October 16, 2017
ADDENDUM #1

Re: INVITATION FOR BIDS: **18-017-NT, Gilead Bloomfield Gym Office Renovation**

Gilead-Bloomfield Gymnasium Office

Renovation Responses to Plan Holder Questions

1 PLAN AT STAIR
SD-1 1/4"=1'-0"

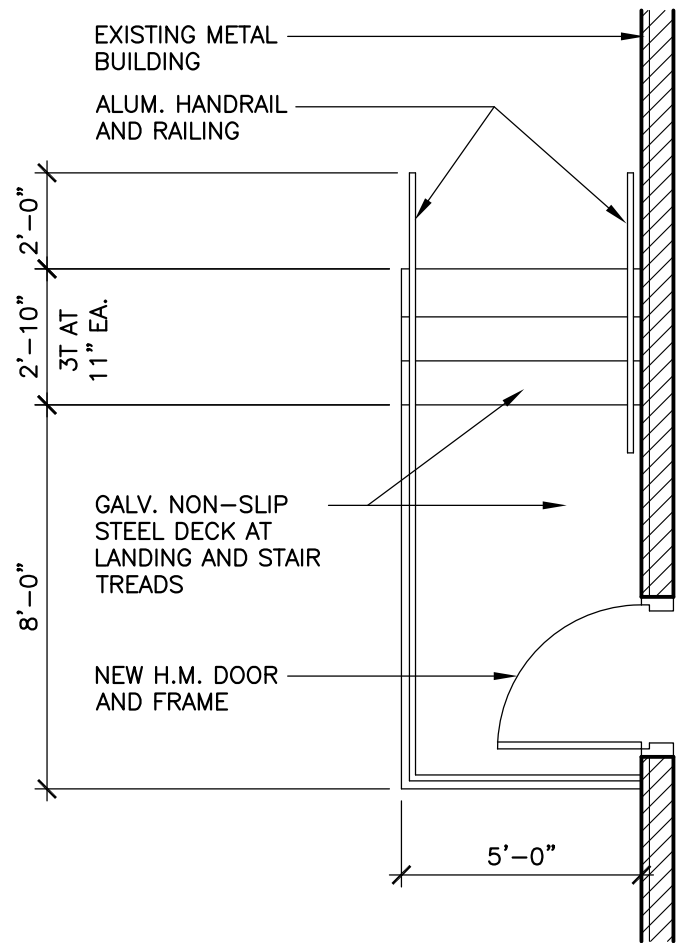
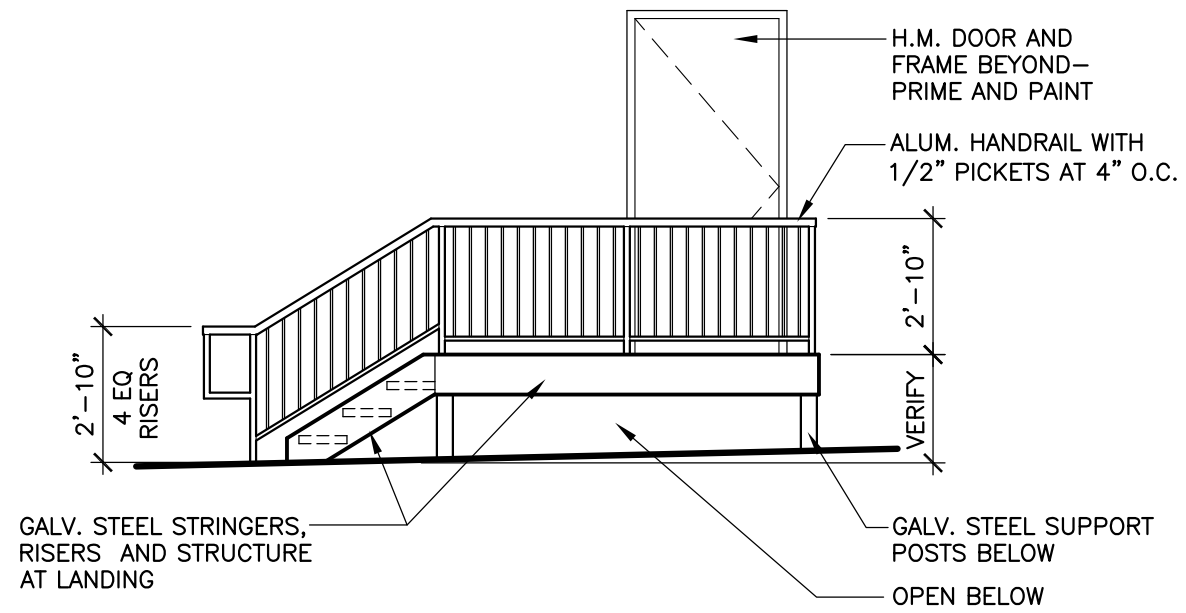
Q: On the left side outside the building there is a note: New Prefab Metal Stair and Railing. You'll need more details than that or what is on A-401.

A: Supplemental drawing SD-1 is attached with enlarged plans and elevations. Additional information for the prefabricated metal stair and landing is included in the technical specifications.
